**Cancer Treatment Center 2022
South Central Regional Medical Center
Laurel, MS**

Addendum No. 3
October 6, 2022

This addendum forms a part of the contract documents and modifies the original plans and specifications dated June 10, 2022.

AD03a

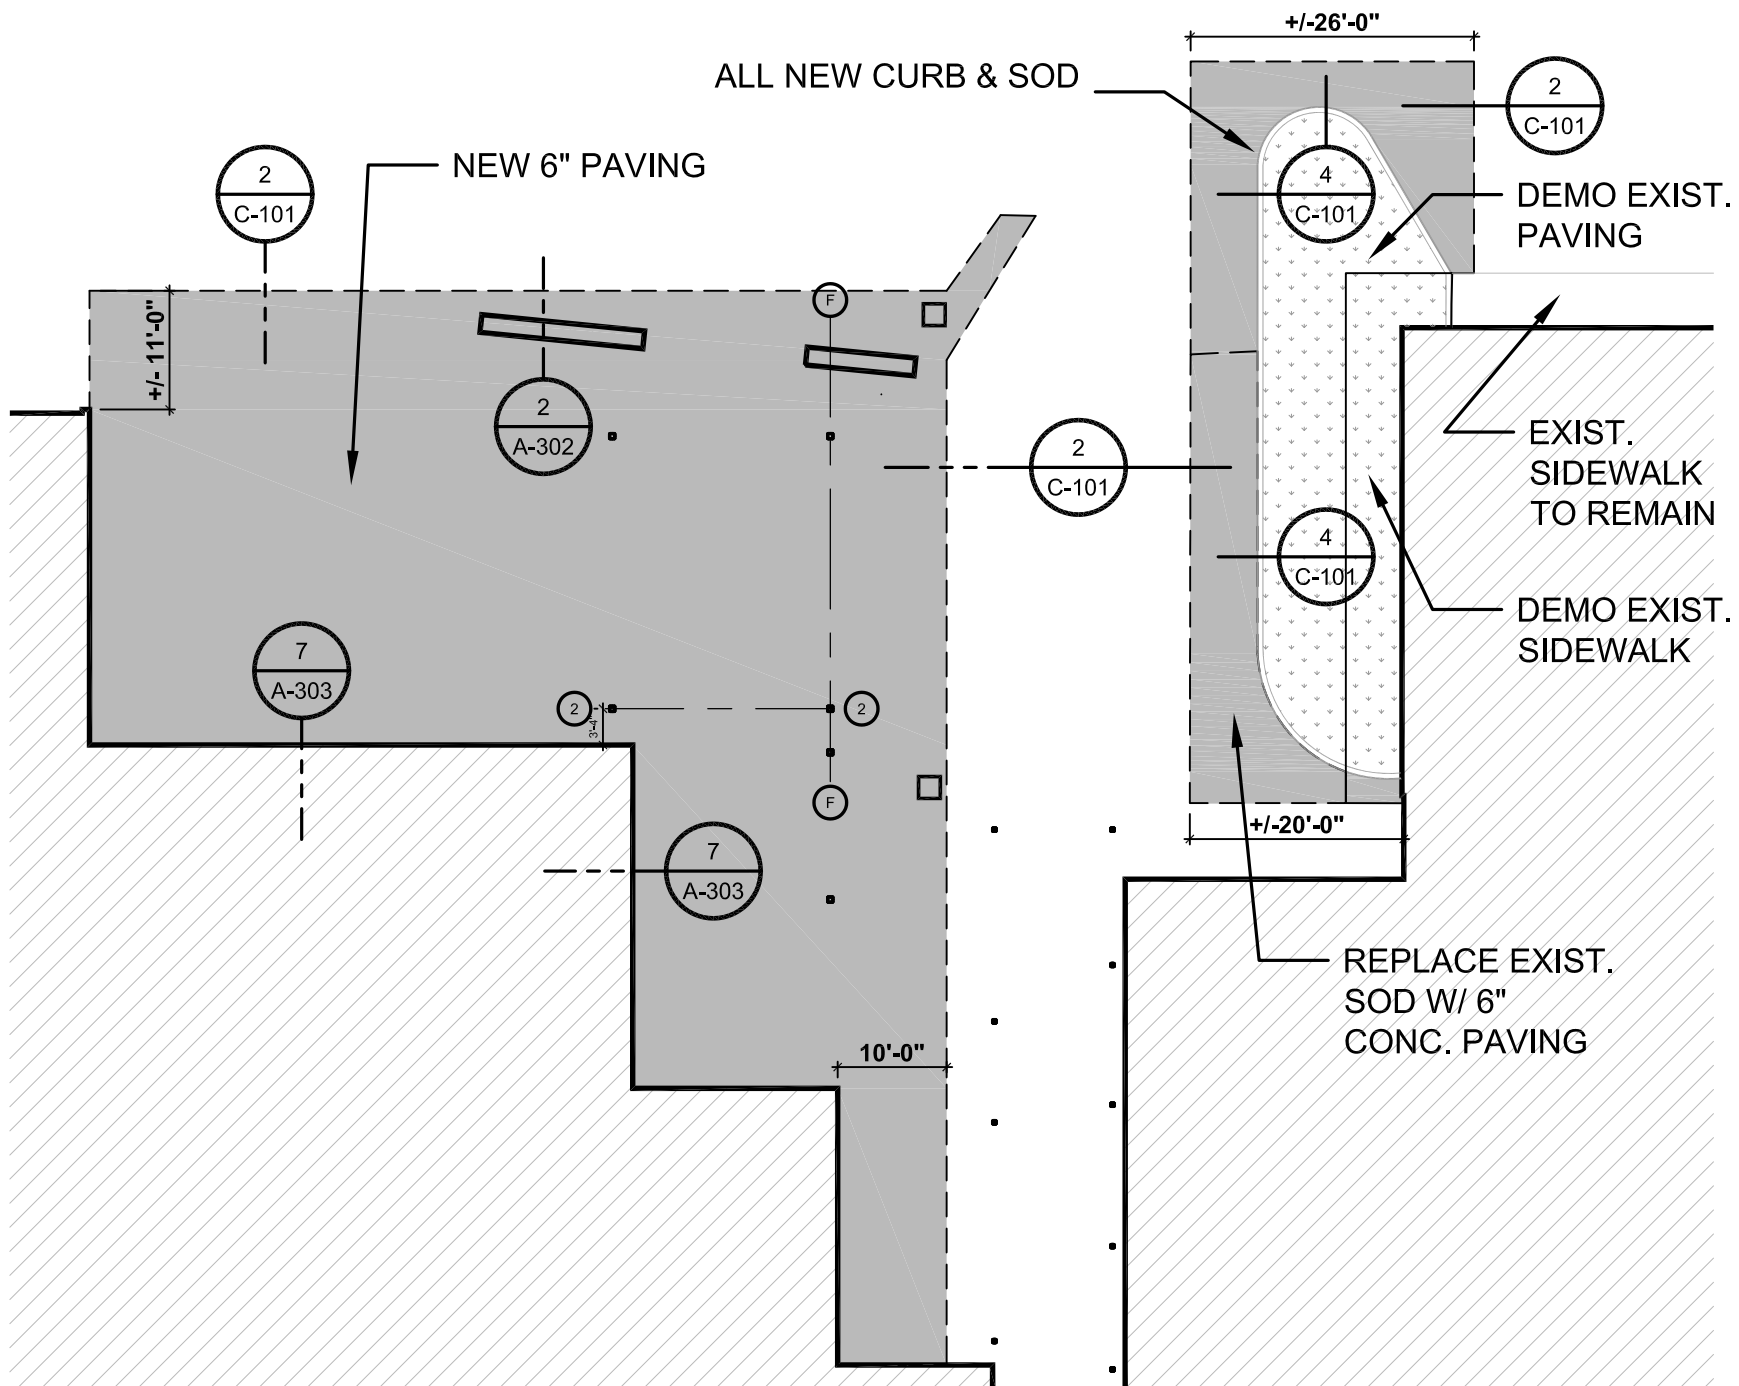
Item 3.1: Sheet C-100, C-101

Note: See Sheet AD03a which clarifies site paving.

AD03b

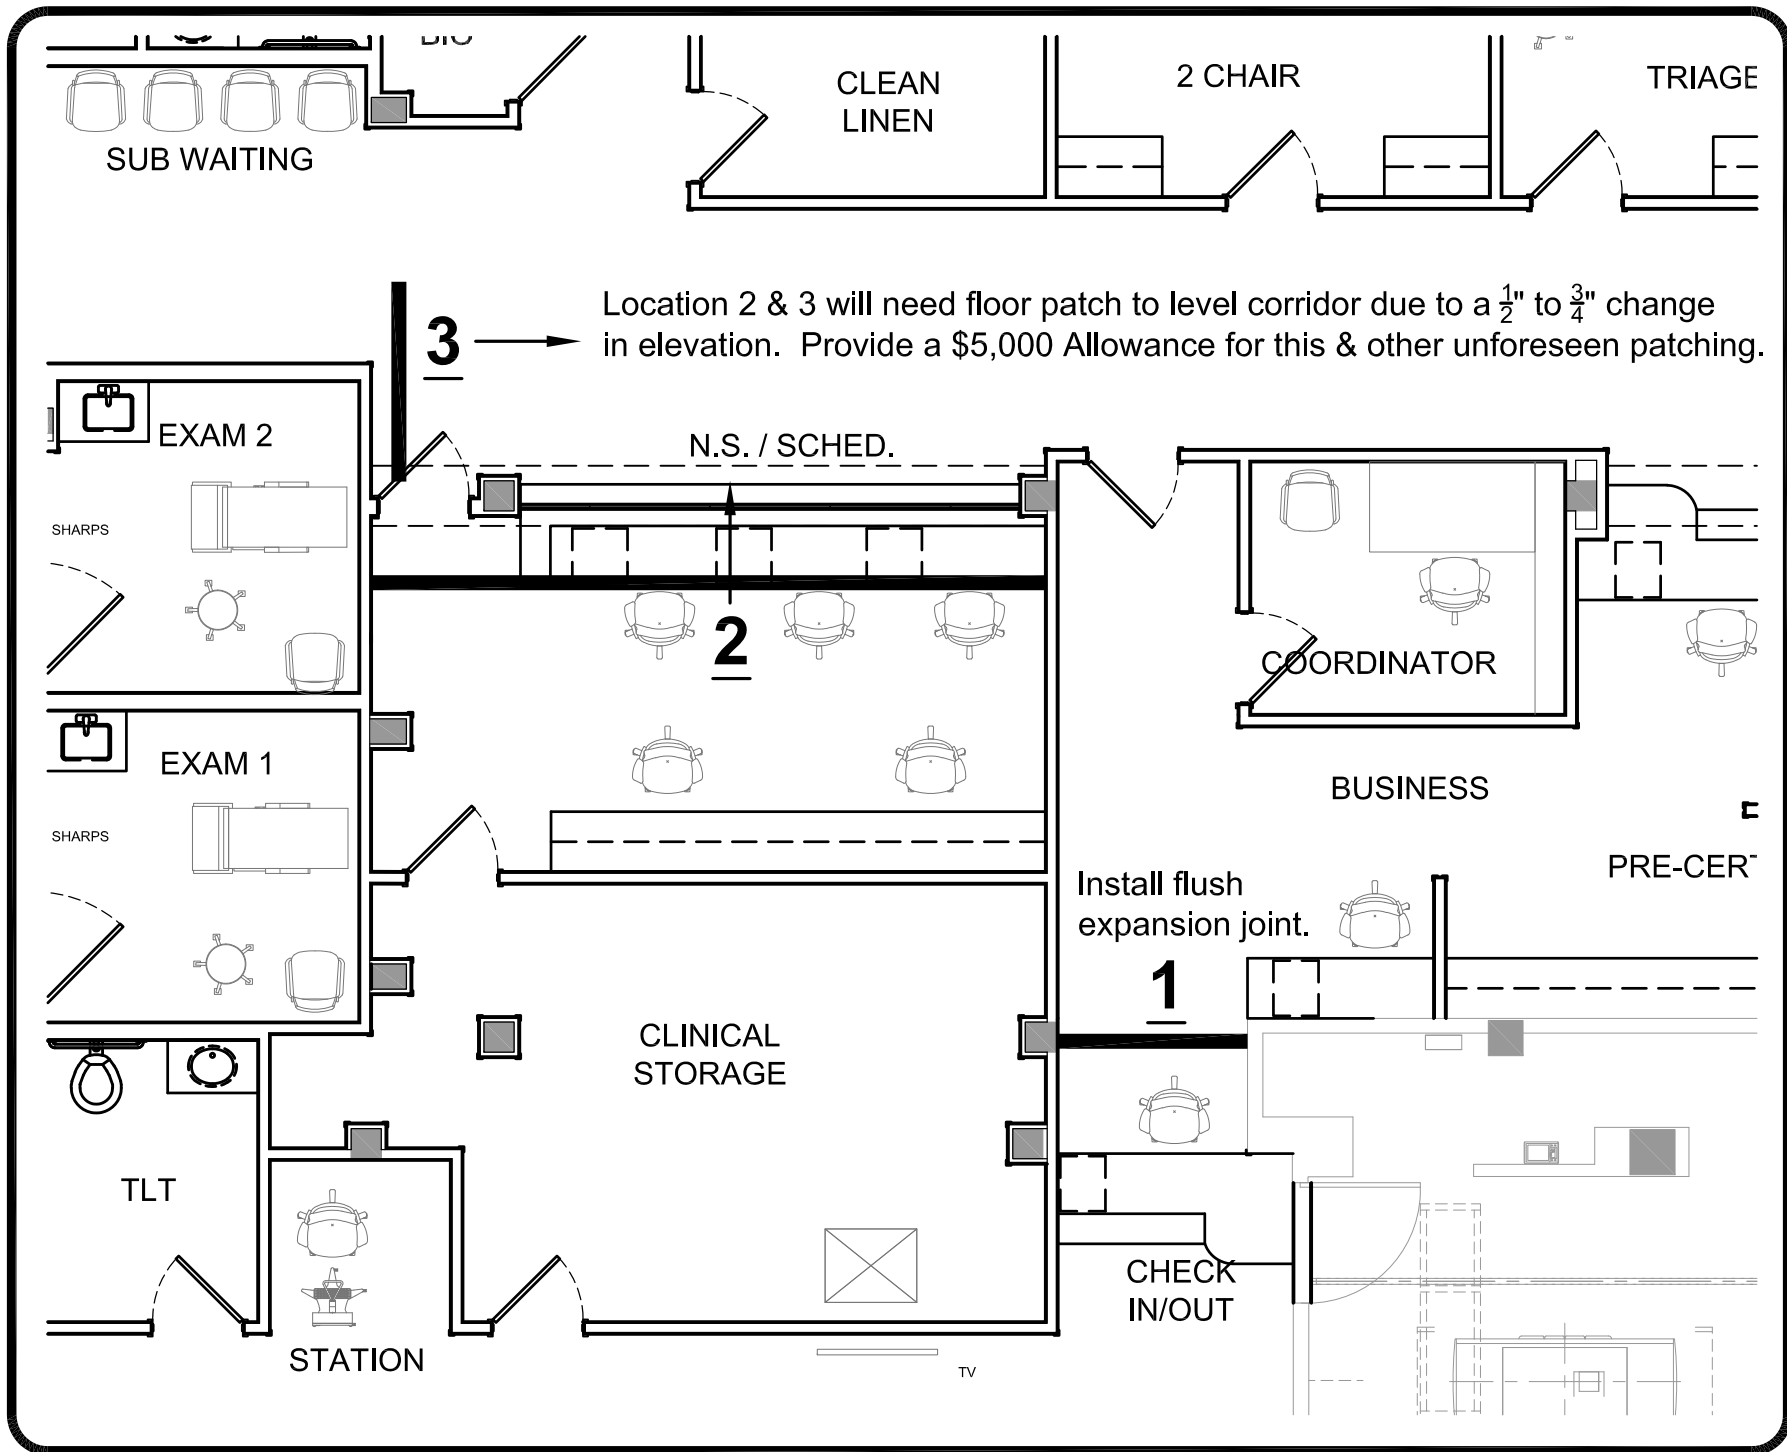
Replace: Sheet I-101 Note under Exist. Corridor legend "~~Patch to match existing~~" with "Replace with a standard VCT. Accent color to be selected by Architect."

Note: Existing Toilet Rooms 1037, 1038, 1061, & 1062 shall receive PT01, P.B.T., & P.W.T in lieu of repairing tile finish as required. See sheet I-101 for material selection.

Note: See Sheet AD03b which adds a \$5,000 Allowance and clarifies flooring as described.

AD03d
 STEEL TUBE
 CLARIFICATION

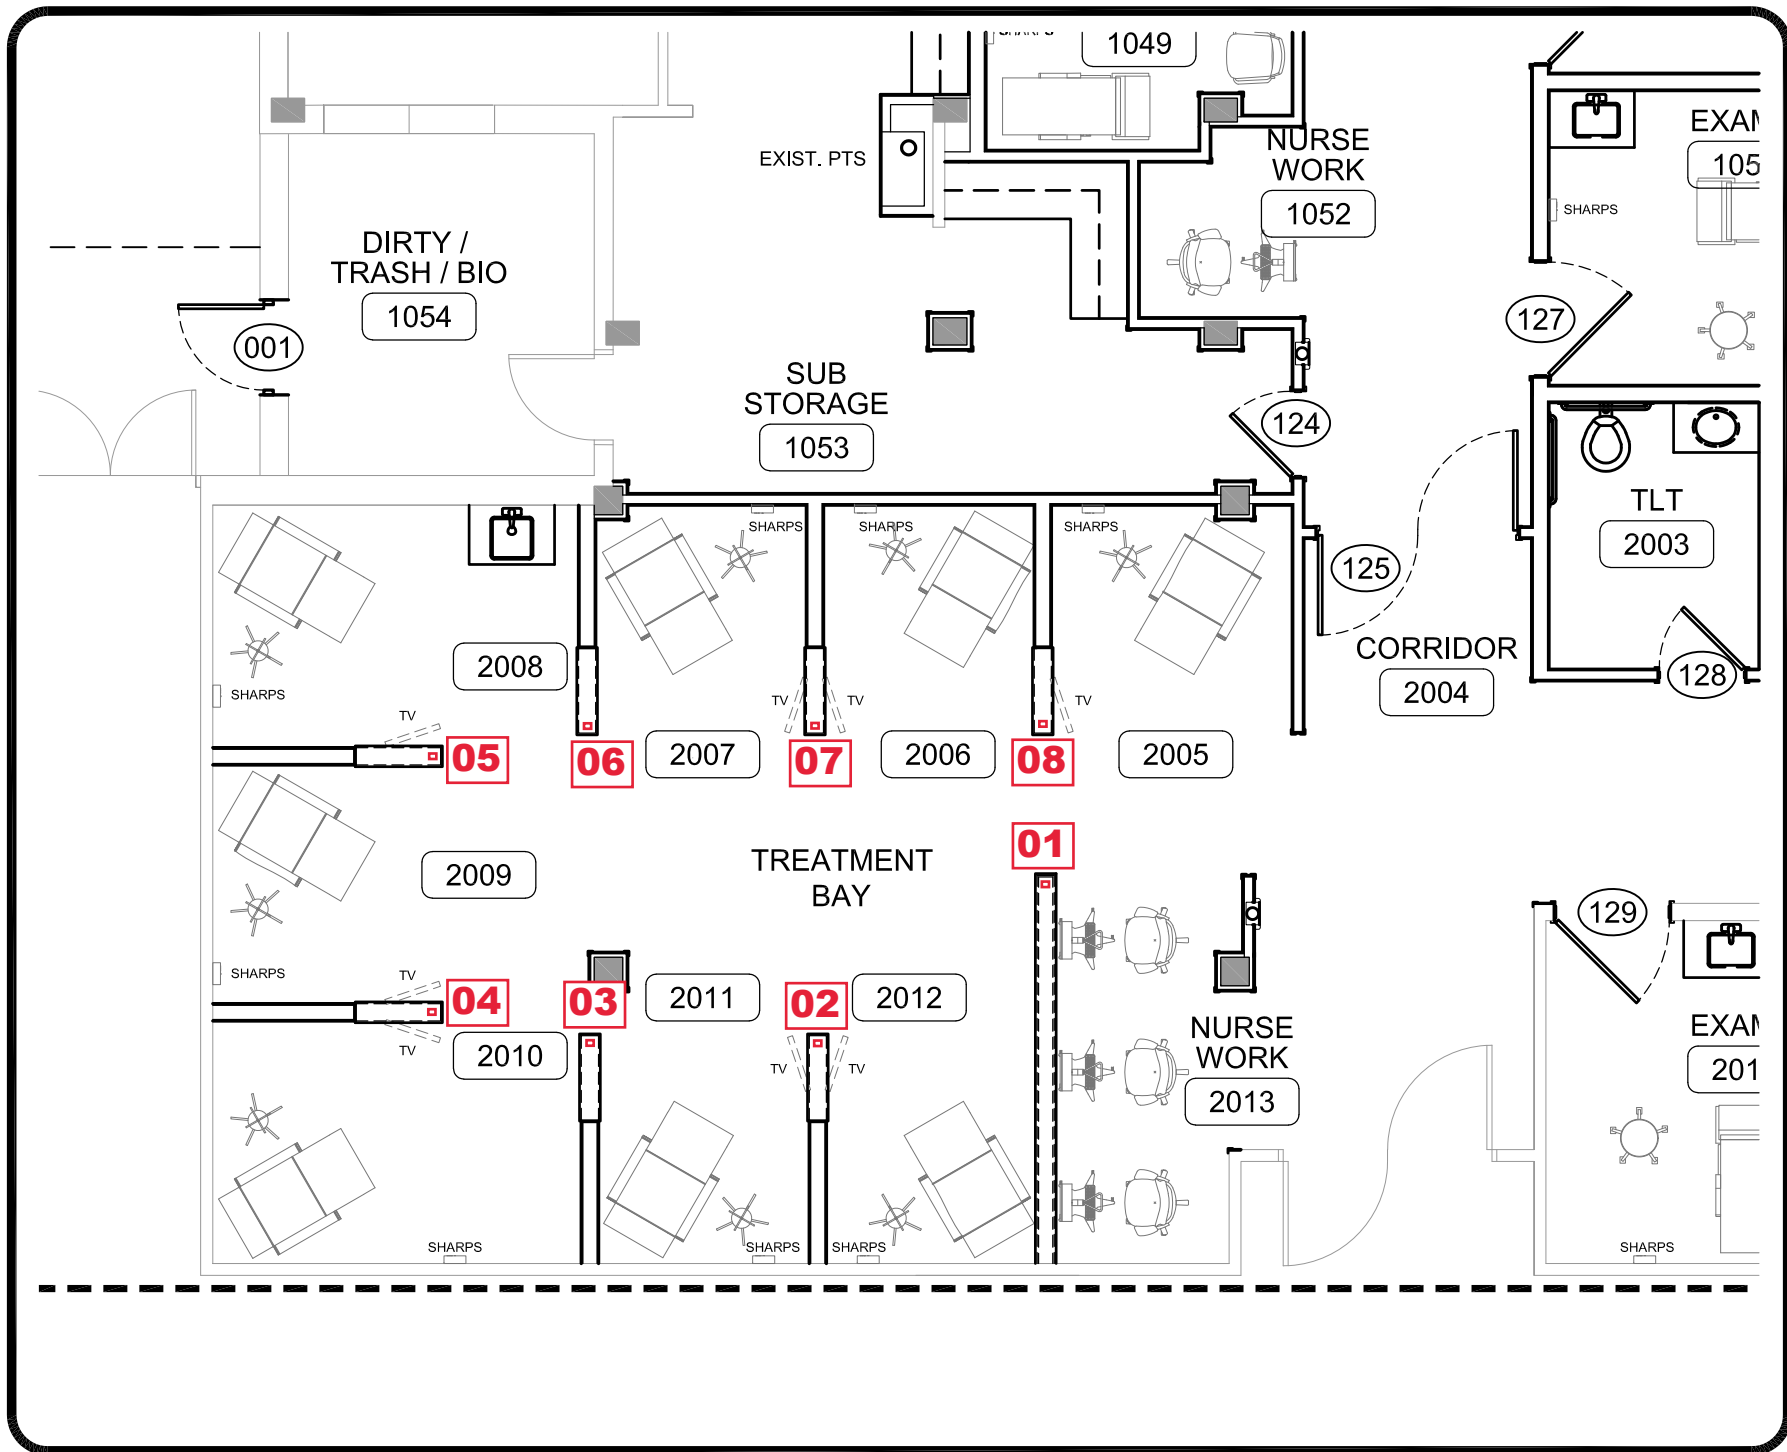
Note: All 2x2 Steel Tube supports are 36" tall and occur in both Treatment Bays called out in the Interior Elevations. See sheets AD03c and AD03d for locations highlighted.

8 TOTAL 2X2 ENDWALL SUPPORTS AT 36" TALL. SEE ABOVE HIGHLIGHTED AREAS FOR LOCATIONS IN THIS TREATMENT BAY.
